AGENDA
FARRAGUT MUNICIPAL PLANNING COMMISSION

December 19, 2019
7:00 p.m. Farragut Town Hall

**MINUTES
FARRAGUT MUNICIPAL PLANNING COMMISSION**

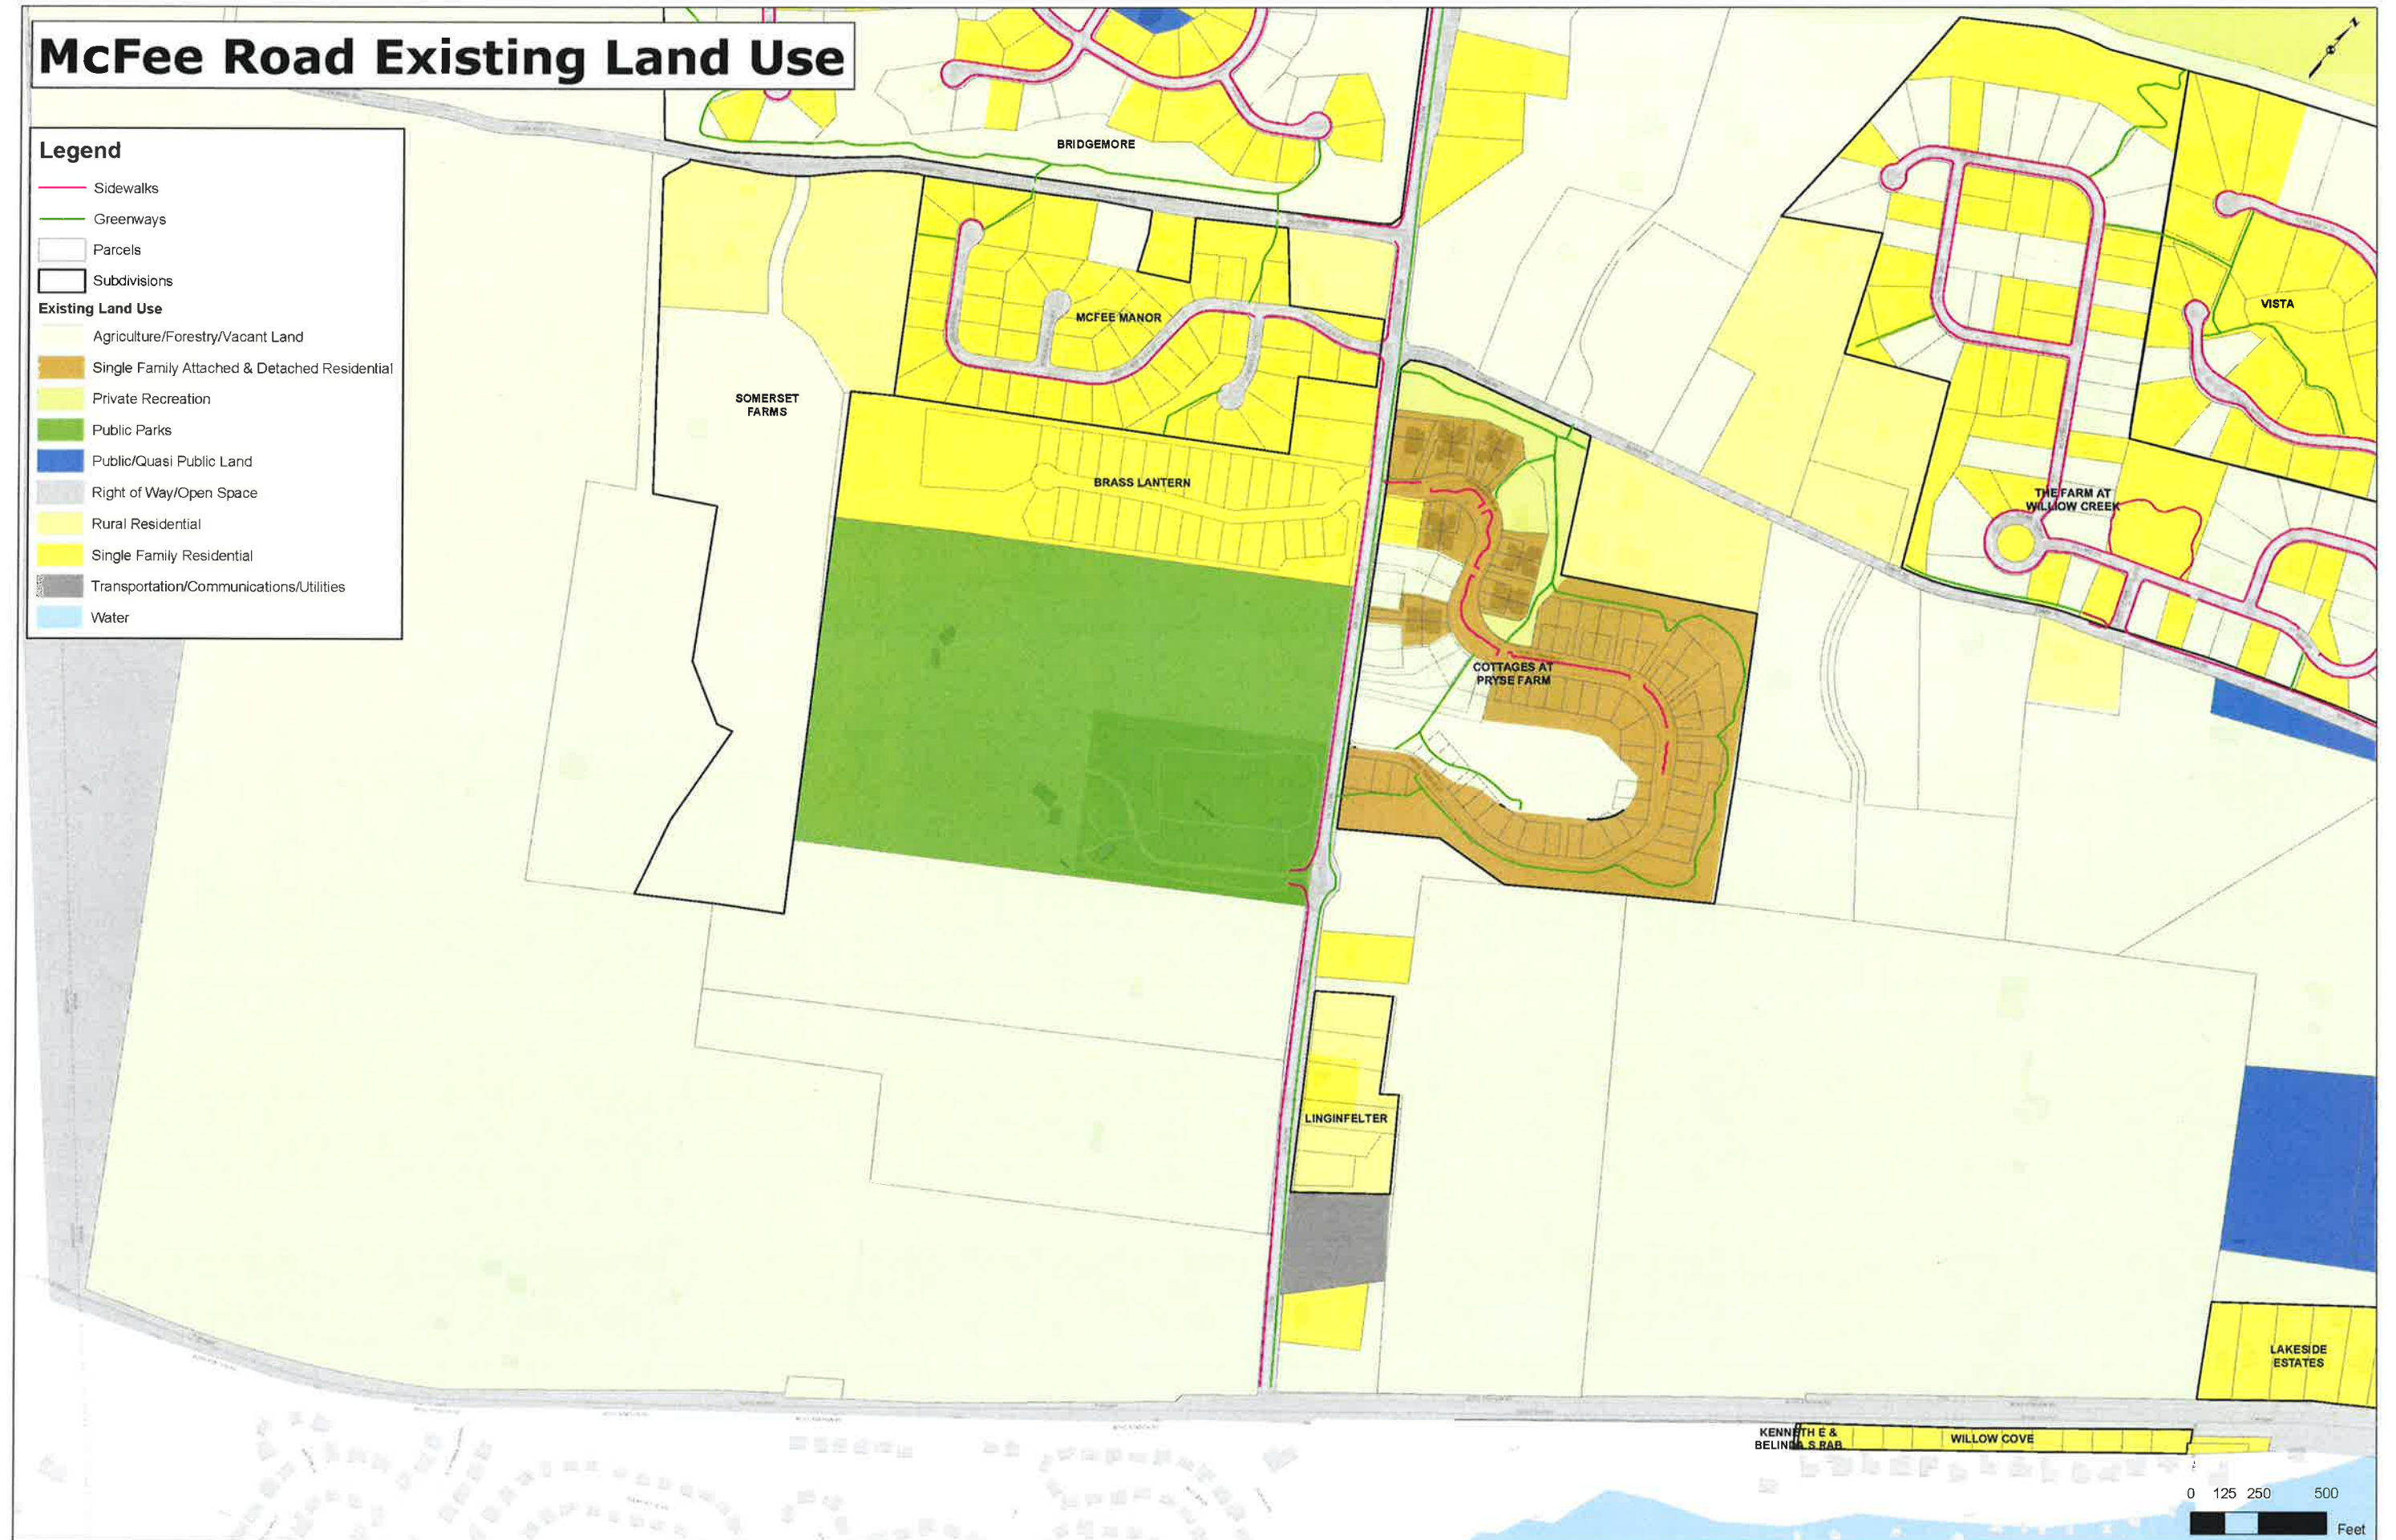
What is this? – referring to black line on map in Cottages at Pryse Farm

SITE LAYOUT PLAN

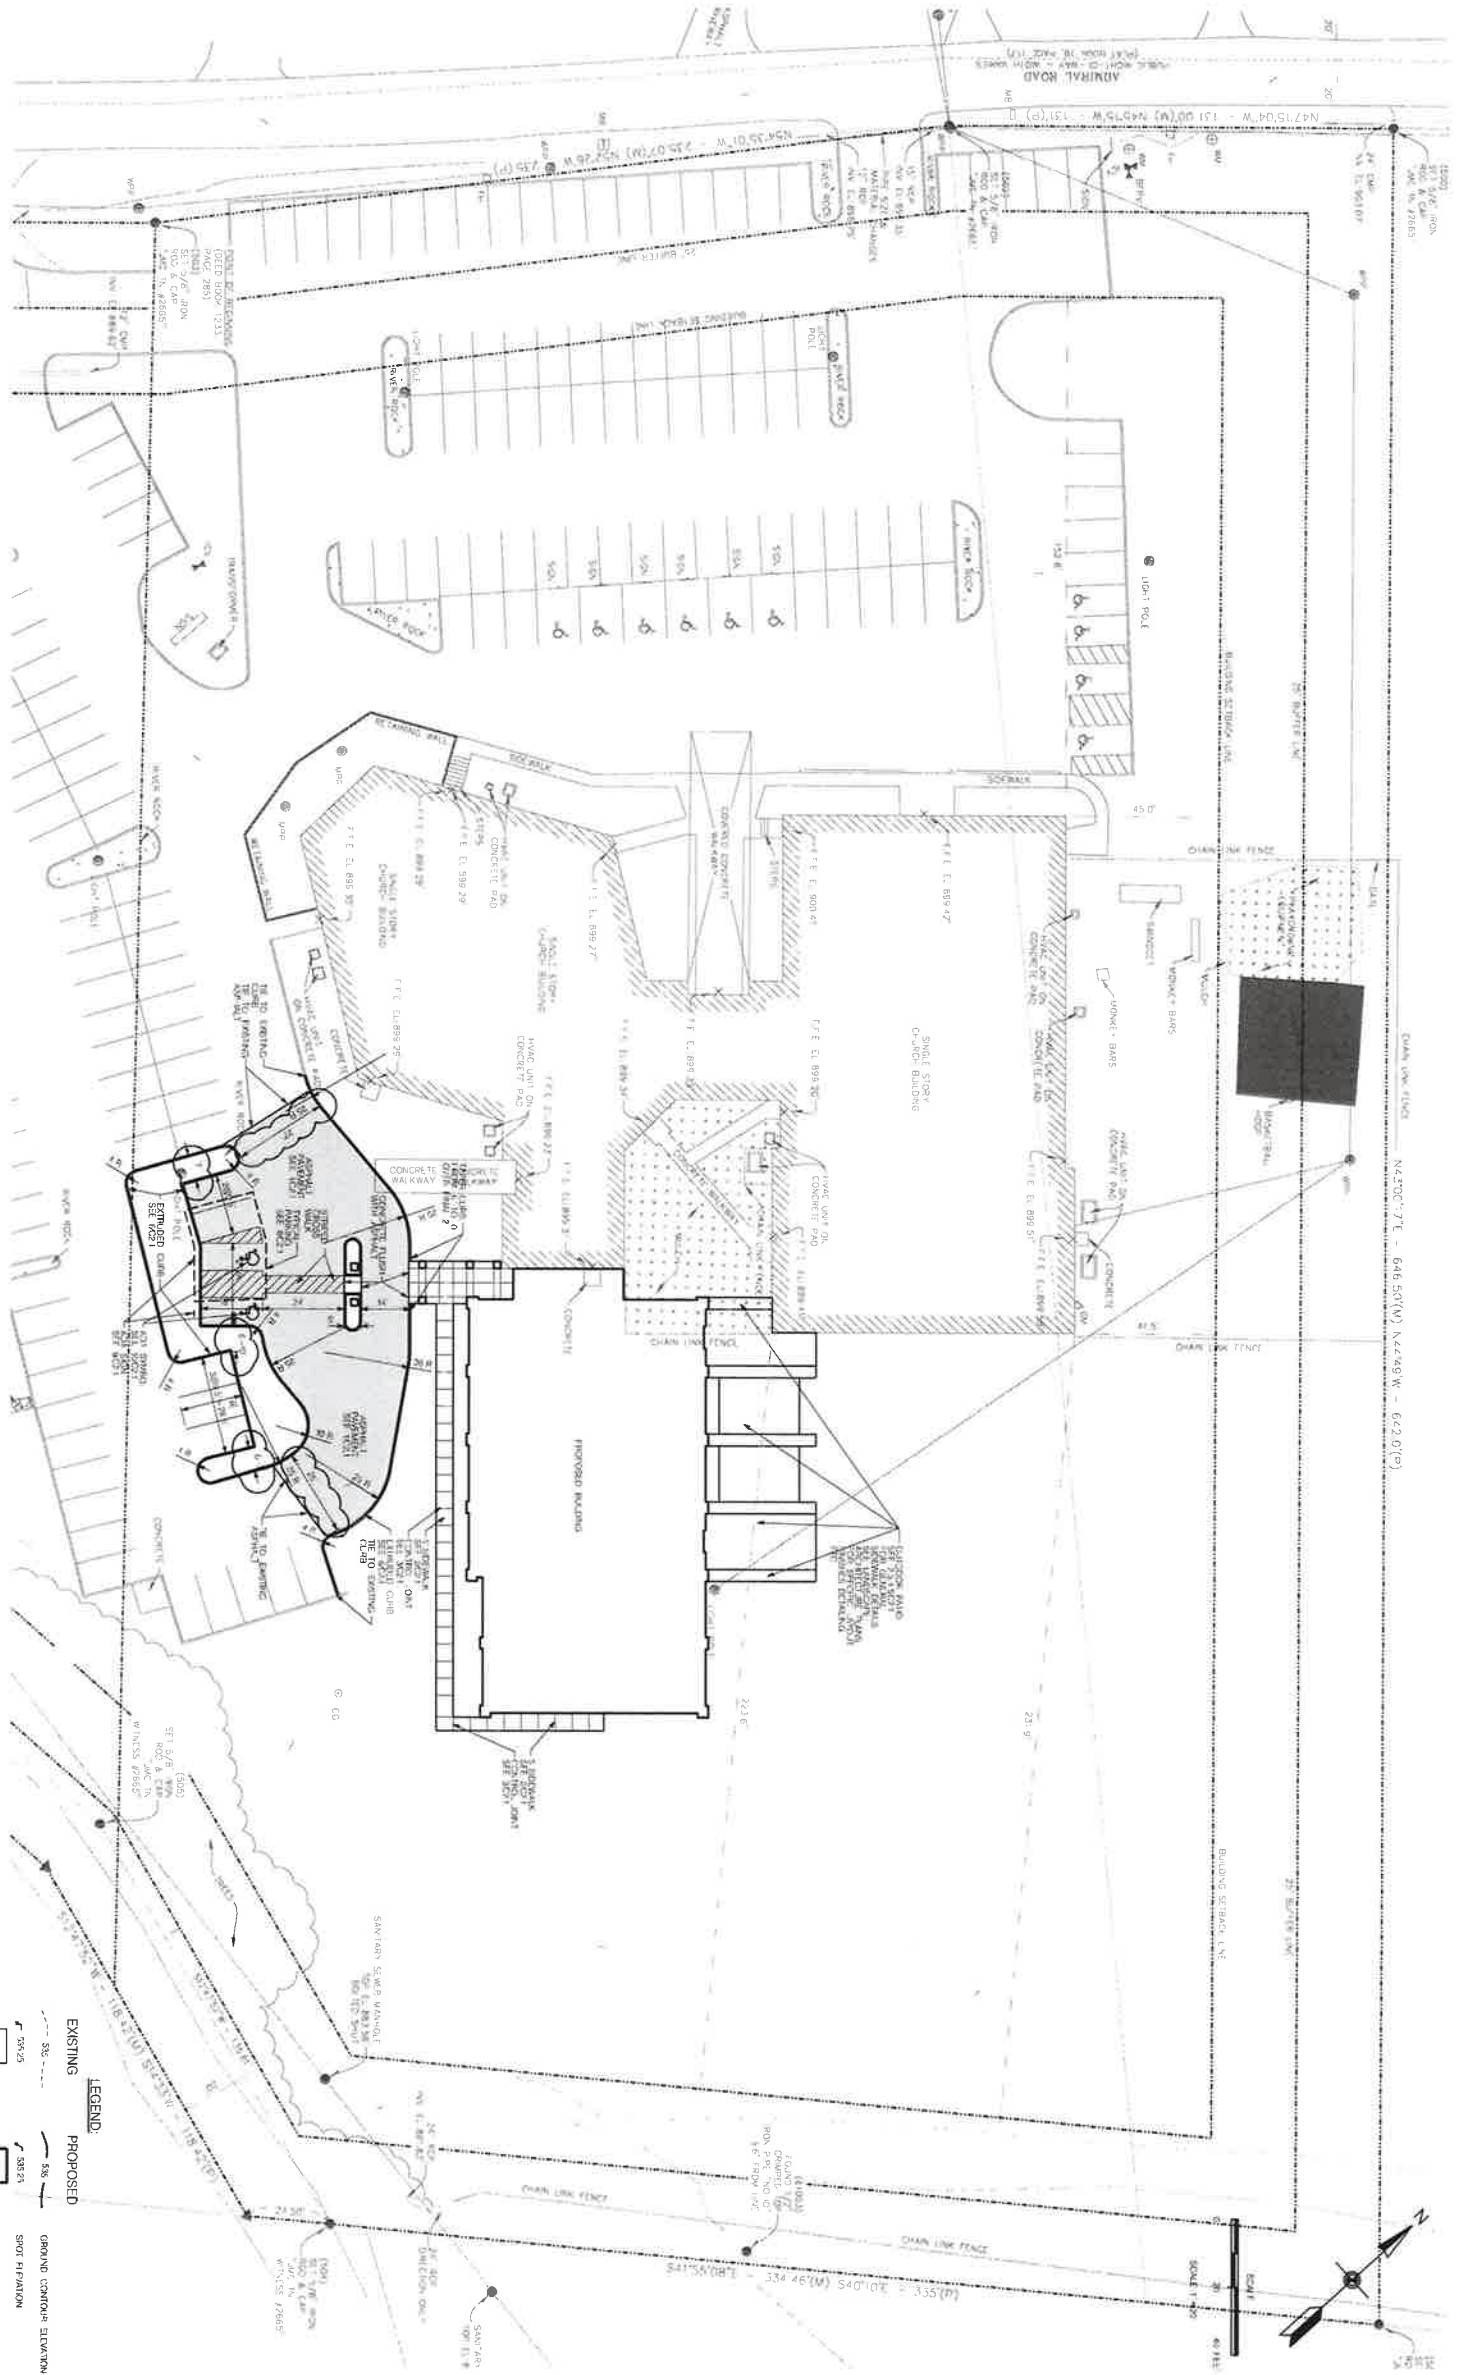
- 1 Comment: Dimensions in Red noted on site plans.

- 8) Comment: Provide parking data.

See revised C1.2 and note the addition of added dimensions indicated on the review letter.

See revised C1.2 and note the correction of the parking summary.

A3.1C

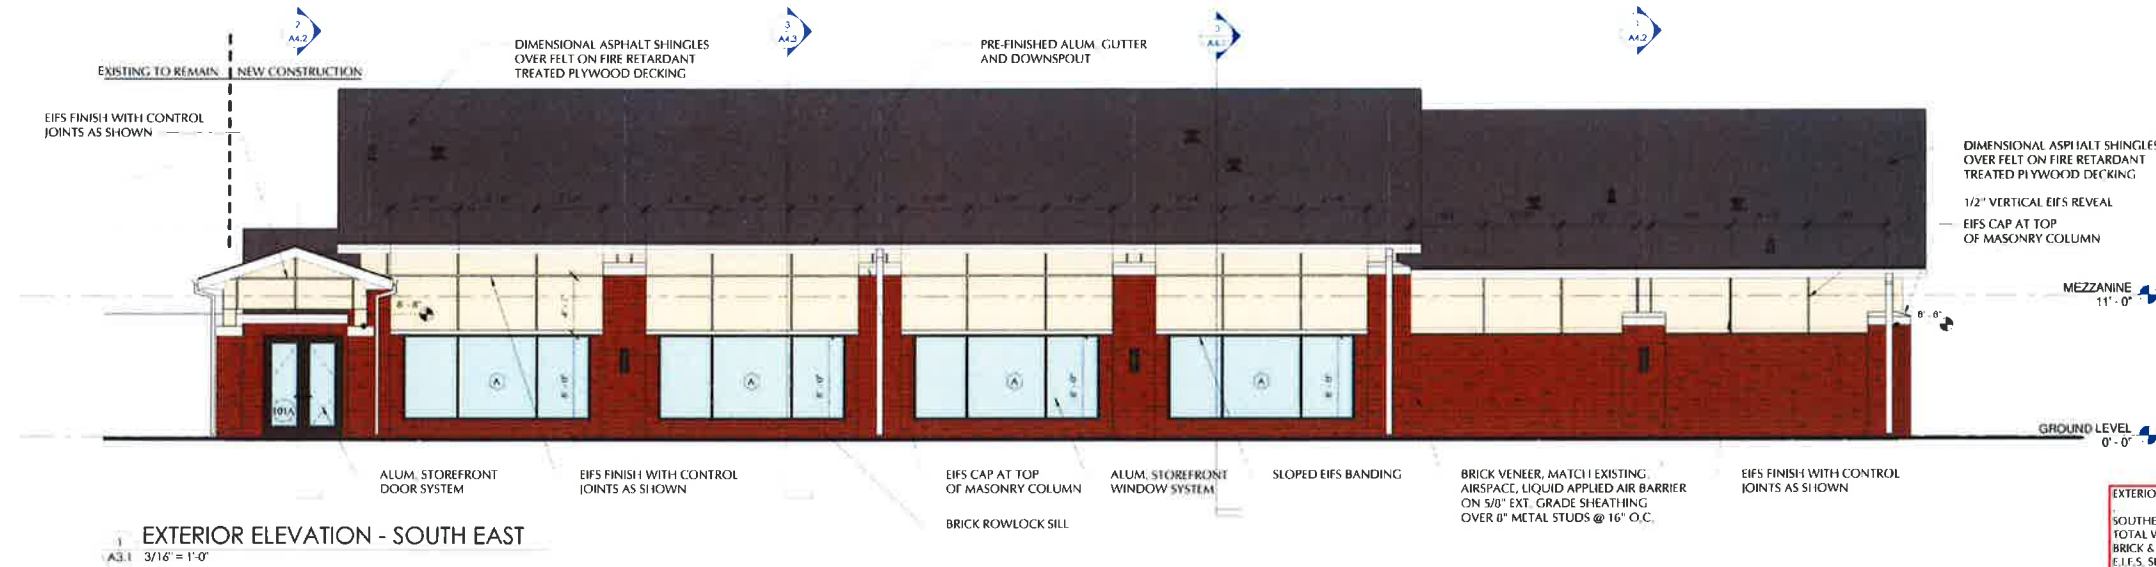
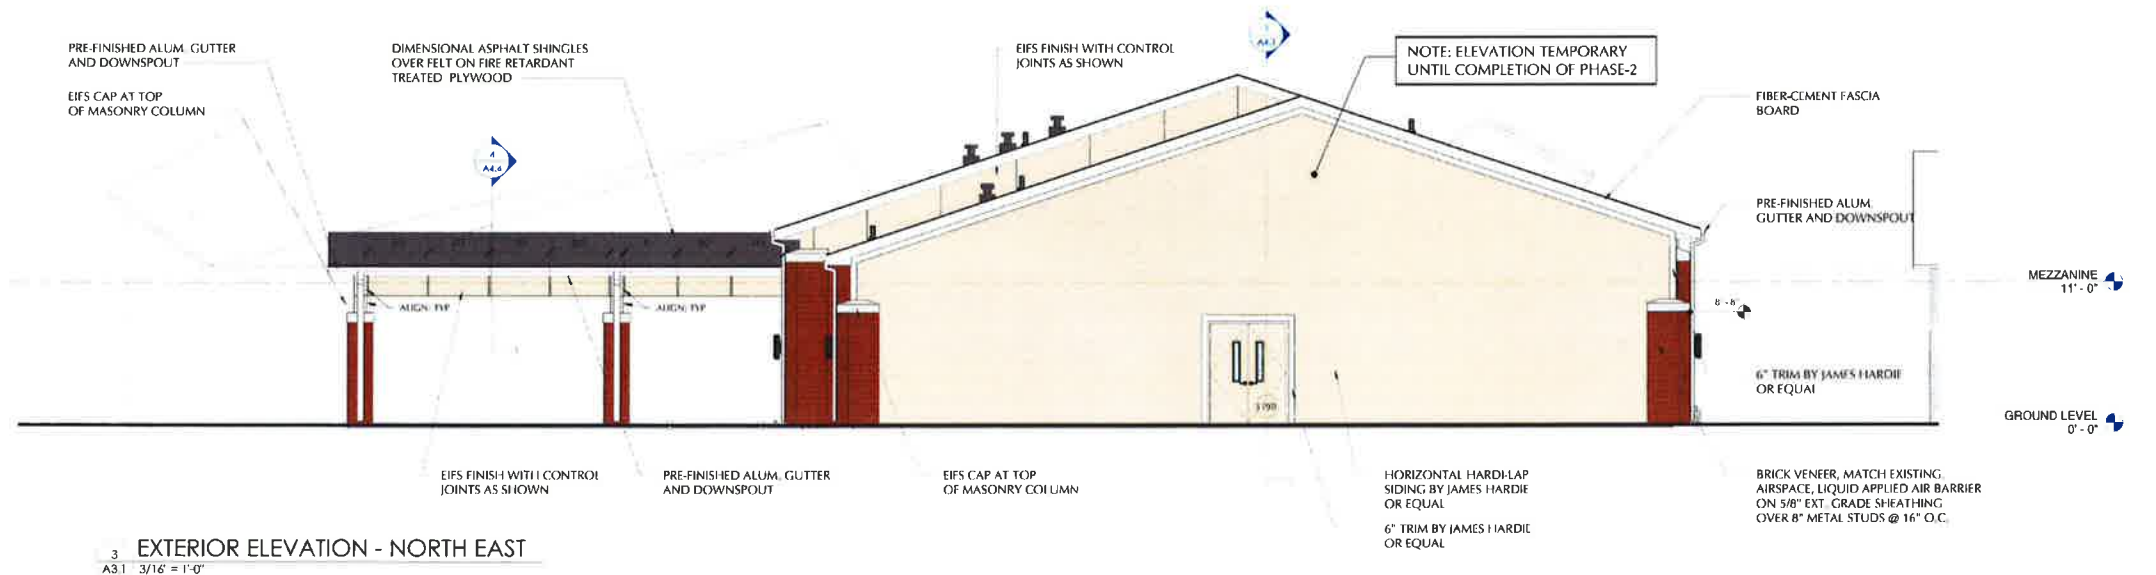
DISCUSSION: As proposed, the northeast wall of the new building does not comply with the Town's Architectural Design Standards and masonry percentages. The applicants have indicated that this is to accommodate a planned future building addition. The Planning Commission will need to discuss this element of the plan.

- 7) Comment: Please include material percentages table to document minimum masonry percentages being met.

See added Sheet A3.1C for material percentages table and calculations. The current addition has 3 main exterior elevations, of which 2 of the permanent elevations are in compliance. The Northeast Elevation has been designed as a temporary exterior condition and will be removed and integrated into an interior wall in future phase -2.

EXTERIOR BUILDING MATERIALS CALCULATIONS:	
SOUTH-EAST ELEVATION:	
TOTAL WALL AREA -	2,593 sf
BRICK & GLAZING WITHIN BRICK -	1,950 sf
E.I.F.S. SECONDARY MATERIAL -	643 sf
MASONRY % PER ELEVATION -	75.3%
NORTH-WEST ELEVATION:	
TOTAL WALL AREA -	1,798 sf
BRICK & GLAZING WITHIN BRICK -	1,405 sf
E.I.F.S. SECONDARY MATERIAL -	393 sf
MASONRY % PER ELEVATION -	78.2%
NORTH-EAST ELEVATION:	
TOTAL WALL AREA -	1,485 sf
BRICK VENEER -	335 sf
FIBER CEMENT BD. & E.I.F.S. -	1,150 sf
MASONRY % PER ELEVATION -	22.5%
NOTE: NORTHEAST ELEVATION HAS BEEN DESIGNED TO BE REMOVED AND INTEGRATED AS AN INTERIOR WALL IN FUTURE PHASE-2 DEVELOPMENT. WE WOULD PROPOSE THIS EXTERIOR ELEVATION NOT BE INCLUDED IN THE OVERALL MASONRY CALCULATIONS DUE TO ITS TEMPORARY EXPOSURE.
